Re: In the Matter of Commonwealth Edison
Company (Braidwood Station, Units 1 and 2),
Docket Nos. 50-456 and 50-457-01

SUMMARY OF CHANGES
IN
WELD DISCREPANCIES AND DISCREPANT WELDS

THE CHANGES* RESULTING FROM THE OCTOBER 1986 RECOUNT OF WELD DISCREPANCIES AND DISCREPANT WELDS ARE SUMMARIZED BELOW:

UNDERCOUNTING SIMILAR DISCREPANCIES
DUE TO ENVELOPING CALCULATIONS

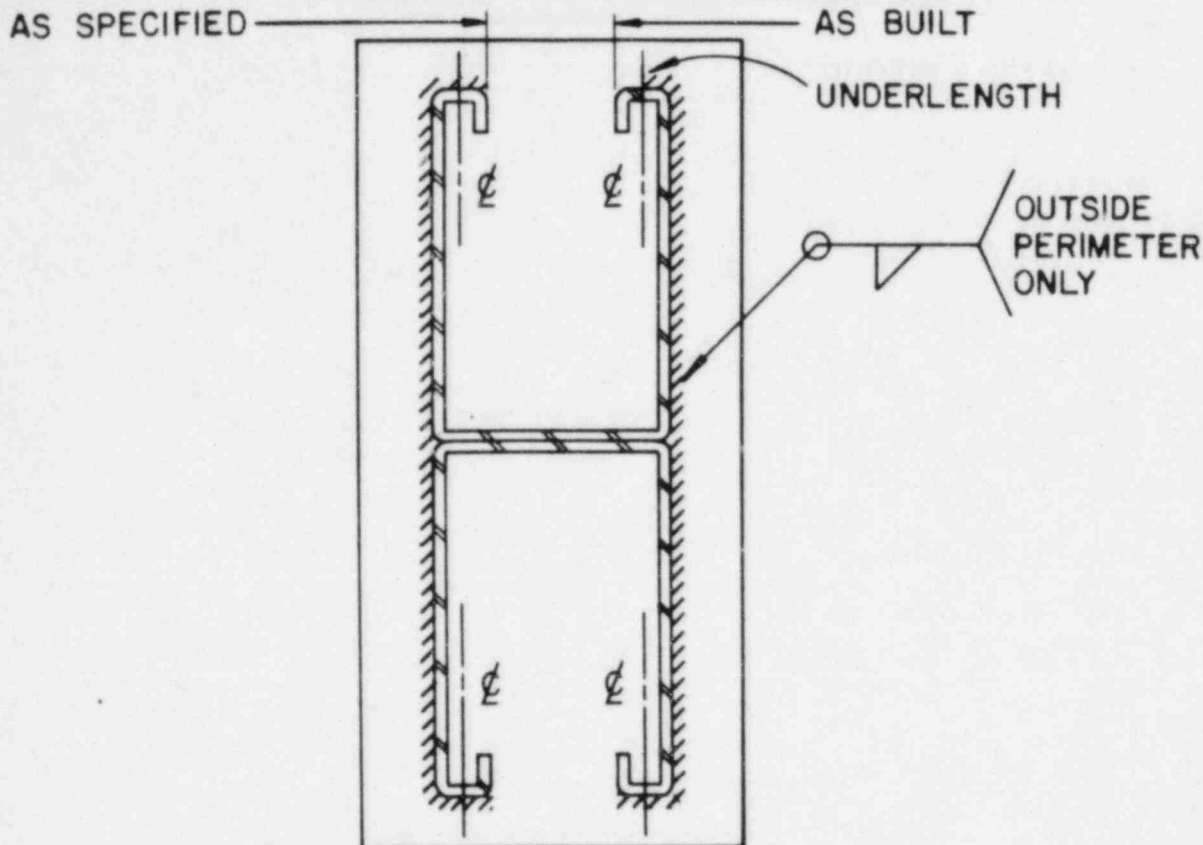
S&L DRAWINGS GENERALLY SPECIFY TYPICAL CONNECTION DETAILS FOR VARIOUS CONNECTIONS ON A COMPONENT. BCAP IDENTIFIED SIMILAR DISCREPANCIES ON VARIOUS TYPICAL CONNECTION DETAILS. FREQUENTLY, S&L CALCULATIONS ENVELOPED SUCH DISCREPANCIES TO SAVE ENGINEERING COSTS.

INITIAL COUNTS - S&L SOMETIMES COUNTED ONLY THE SPECIFIC DISCREPANCIES ADDRESSED IN THE ENVELOPING CALCULATIONS.

OCTOBER 1986 COUNT - S&L COUNTED ALL DISCREPANCIES.

THIS SITUATION IS RESPONSIBLE FOR APPROXIMATELY 20% OF THE NET CHANGE FOR WELD DISCREPANCIES IN THE CPH CONSTRUCTION CATEGORY.

DV-2 CONNECTION UNDERSIZE WELDS

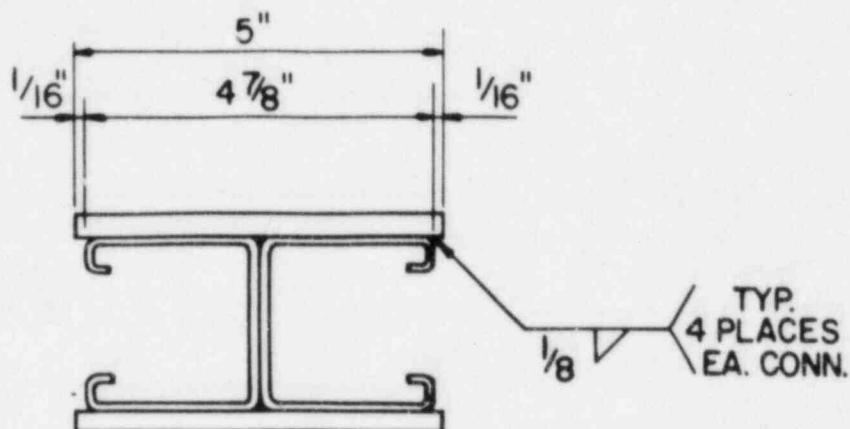
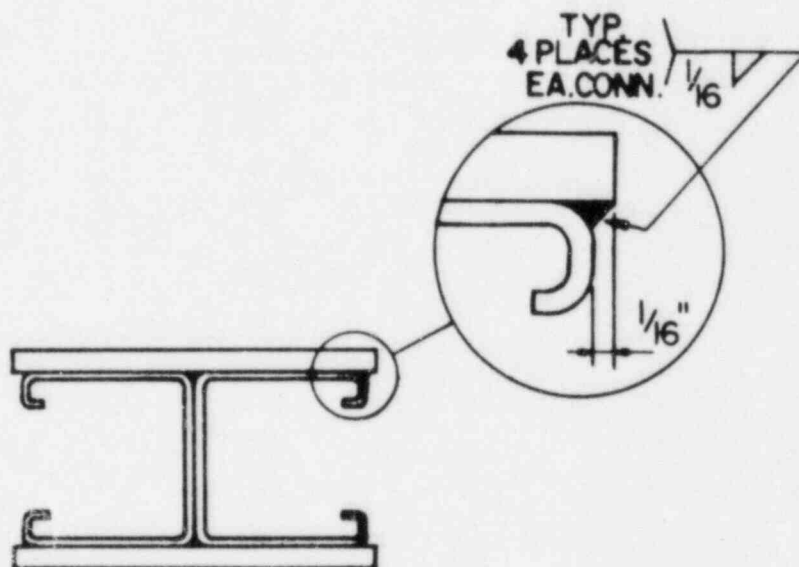
TYPICALLY THESE ARE SYSTEM CONTROL WELDS.

S&L DRAWING 20-E-0-3263, REV. W ACCEPTED AS-BUILT CONDITION
GENERICALLY ON 9/23/83.

BCAP DID NOT INVALIDATE THIS CONDITION.

INITIAL COUNTS - S&L SOMETIMES TREATED THIS AS DISCREPANT CONDITION -
SOMETIMES NOT.

OCTOBER 1986 COUNT - ALWAYS TREATED AS DISCREPANT CONDITION

THIS SITUATION IS RESPONSIBLE FOR APPROXIMATELY 15% PERCENT OF
NET CHANGE FOR WELD DISCREPANCIES IN THE CPH CONSTRUCTION CATEGORY.

DV-1,2,4 & 5 - UNDERLENGTH WELDS

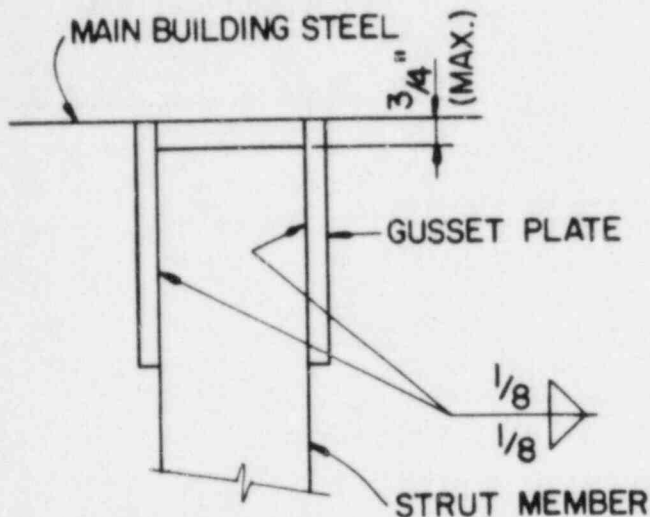
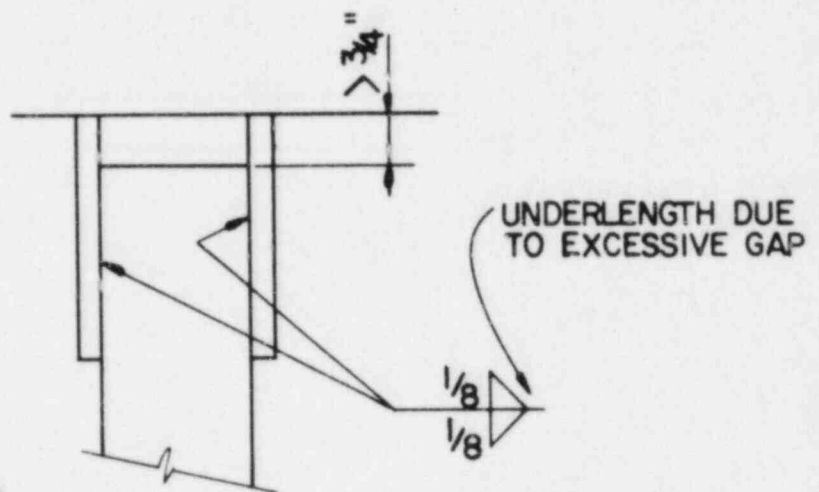
TYPICALLY THESE ARE SYSTEMS CONTROL WELDS. THE S&L DRAWINGS SPECIFY A FULL-LENGTH WELD BETWEEN THE GUSSET PLATES AND THE STRUT MEMBER AND SHOW A DIMENSION FOR THE GAP BETWEEN THE STRUT MEMBER AND THE MAIN BUILDING STEEL.

THE BCAP OBSERVATIONS SOMETIMES INDICATE THAT THIS WELD IS UNDERLENGTH. OTHER TIMES THE OBSERVATIONS MERELY INDICATE THAT THE GAP BETWEEN THE STRUT MEMBER AND THE MAIN BUILDING STEEL EXCEEDS THAT CALLED FOR IN THE DRAWINGS (WHICH IMPLIES THE WELDS BETWEEN THE STRUT MEMBER AND THE GUSSET PLATES ARE UNDERLENGTH).

INITIAL COUNTS - SOMETIMES S&L IDENTIFIED THESE AS UNDERLENGTH WELDS, SOMETIMES NOT.

OCTOBER 1986 COUNT - S&L IDENTIFIED THESE AS UNDERLENGTH WELDS.

THIS SITUATION IS RESPONSIBLE FOR APPROXIMATELY 10% OF THE NET CHANGE IN THE CPH CONSTRUCTION CATEGORY.

DV-14, DV-19 GUSSET PLATE - COPE

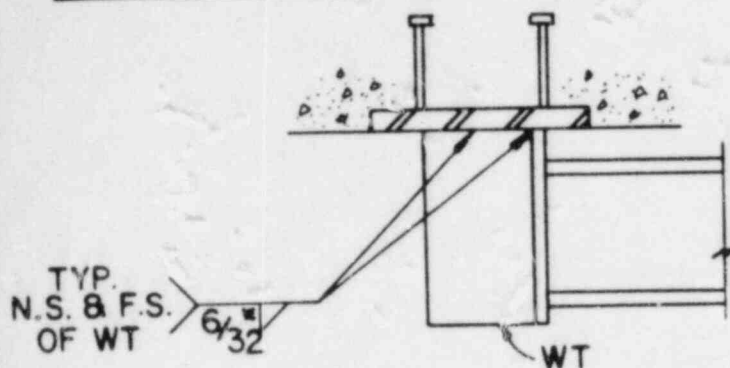
S&L DRAWINGS CALLED FOR WELDS RUNNING THE LENGTH OF THE GUSSET PLATE. BCAP OBSERVATIONS INDICATED THAT THE WELDS WERE "UNDERLENGTH" DUE TO THE CONSTRUCTION COPE. HOWEVER, A COPE IS REQUIRED TO INSTALL THIS DETAIL.

INITIAL COUNTS - S&L DID NOT COUNT THESE WELDS AS UNDERLENGTH BASED ON A JUDGMENT THAT THE DETAIL COULD NOT HAVE BEEN INSTALLED IN ANY OTHER WAY, AND THAT THE WELD WAS NOT DISCREPANT. HOWEVER, THIS WAS IMPROPER BECAUSE BCAP HAD NOT INVALIDATED THESE DISCREPANCIES.

OCTOBER 1986 COUNT - S&L COUNTED THESE AS WELD DISCREPANCIES.

THIS SITUATION IS RESPONSIBLE FOR APPROXIMATELY 5% OF THE NET CHANGE IN THE WELD DISCREPANCIES IN THE CPH CONSTRUCTION CATEGORY.

AUXILIARY STEEL CONN.- OVERSIZE WELDS

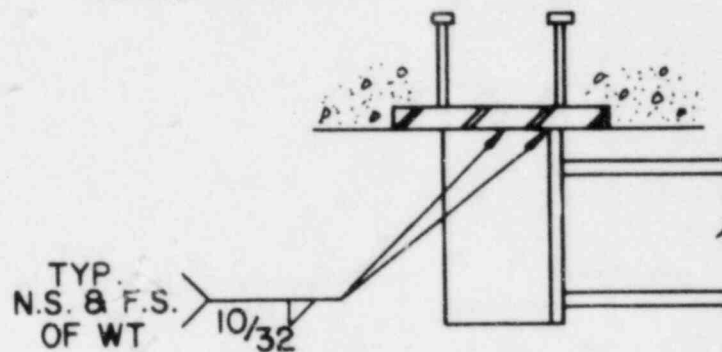
THE S&L DRAWING FOR THIS ITEM CALLS FOR 6/32 INCH FILLET WELDS WITH A MAXIMUM SIZE OF 9/32 INCH. BCAP OBSERVATIONS SHOW THE SIZE OF THESE WELDS TO BE 10/32 INCH.

INITIAL COUNTS - S&L DID NOT COUNT THESE WELDS AS DISCREPANT BECAUSE, IN GENERAL, OVERSIZED WELDS ARE PERMITTED BY DESIGN DRAWINGS. THIS JUDGMENT WAS INAPPROPRIATE BECAUSE BCAP HAD NOT INVALIDATED THIS OBSERVATION.

OCTOBER 1986 COUNT - S&L COUNTED THESE OVERSIZED WELDS AS DISCREPANT.

THIS SITUATION IS RESPONSIBLE FOR APPROXIMATELY 5% OF THE NET CHANGE IN THE CPH CONSTRUCTION CATEGORY.

USE OF GENERIC MOUNTING DETAIL
IN LIEU OF UNIQUE MOUNTING DETAIL
FOR EIN-114

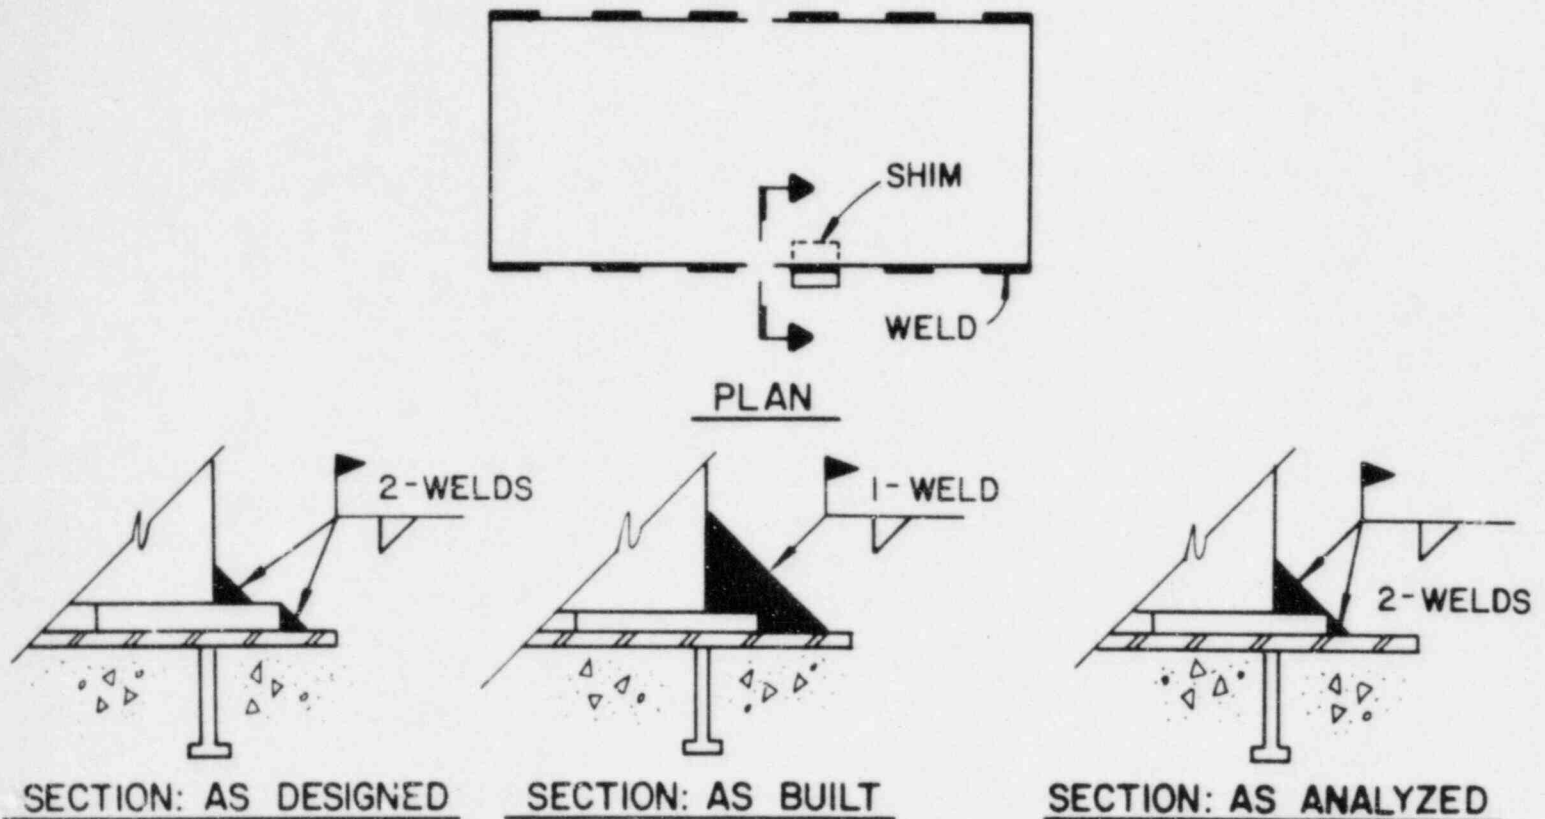
S&L DRAWINGS SPECIFY GENERIC AND UNIQUE MOUNTING DETAILS FOR ELECTRICAL EQUIPMENT. BCAP IDENTIFIED WELD SIZE DISCREPANCIES ON EIN-114, AND FURNISHED A WELD MAP SHOWING WELD SIZES.

INITIAL COUNTS - S&L COUNTED WELD DISCREPANCIES ON EIN-114 BASED ON THE GENERIC DETAIL, WHICH SPECIFIED 1/8 INCH FILLET WELDS.

OCTOBER 1986 COUNT - S&L COUNTED DISCREPANCIES ON EIN-114 BASED ON THE UNIQUE DETAIL, WHICH SPECIFIED 1/2 INCH FILLET WELDS. THIS RESULTED IN COUNTING ADDITIONAL WELD DISCREPANCIES.

THIS SITUATION IS RESPONSIBLE FOR APPROXIMATELY 10% OF THE NET CHANGE FOR WELD DISCREPANCIES IN THE EIN CONSTRUCTION CATEGORY.

SHIM WELDS

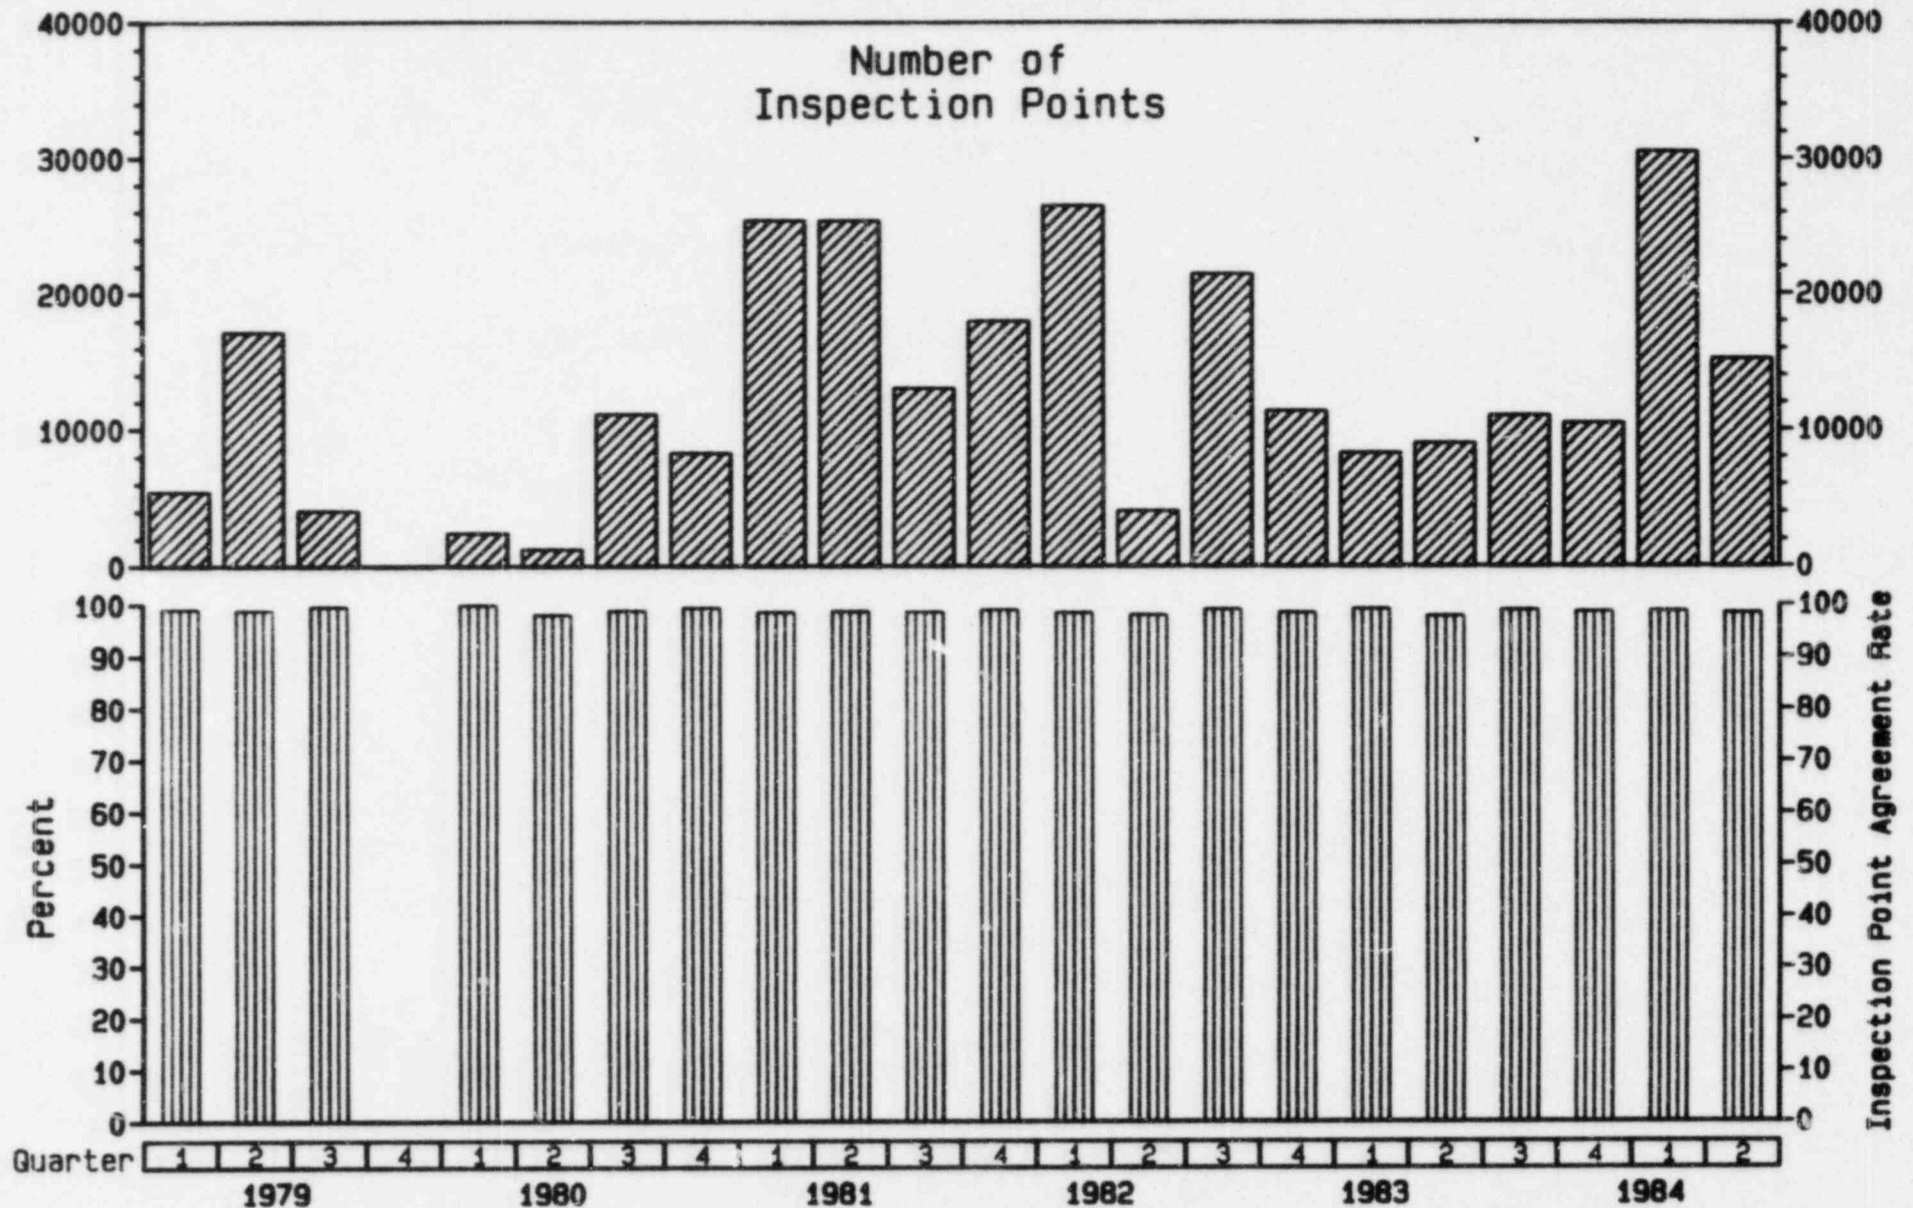
S&L DRAWINGS CALL FOR THE USE OF SHIM PLATES, AS REQUIRED, UNDER PIECES OF EQUIPMENT. THE WELD BETWEEN THE EQUIPMENT AND THE SHIM AND THE WELD BETWEEN THE SHIM AND THE EMBEDMENT PLATE ARE SPECIFIED AS SEPARATE WELDS.

FREQUENTLY, BCAP OBSERVATIONS IDENTIFY ONLY ONE LARGE WELD ENTIRELY COVERING THE SHIM PLATE WITH A TYPICAL NOTATION "SHIM PLATE LOCATION INDETERMINATE." IN ANALYZING FOR DESIGN SIGNIFICANCE, S&L MADE THE WORST CASE ASSUMPTION THAT THE SHIM EXTENDS TO THE FACE OF THE WELD.

INITIAL COUNTS - S&L TYPICALLY COUNTED THESE SHIM WELDS AS ONE WELD.

OCTOBER 1986 COUNT - S&L COUNTED THESE AS TWO SEPARATE WELDS, WHICH GENERALLY RESULTS IN MULTIPLYING THE NUMBER OF IDENTIFIED WELD DISCREPANCIES BY TWO.

THIS SITUATION IS RESPONSIBLE FOR APPROXIMATELY 55% OF THE NET CHANGE IN THE EIN CONSTRUCTION CATEGORY.
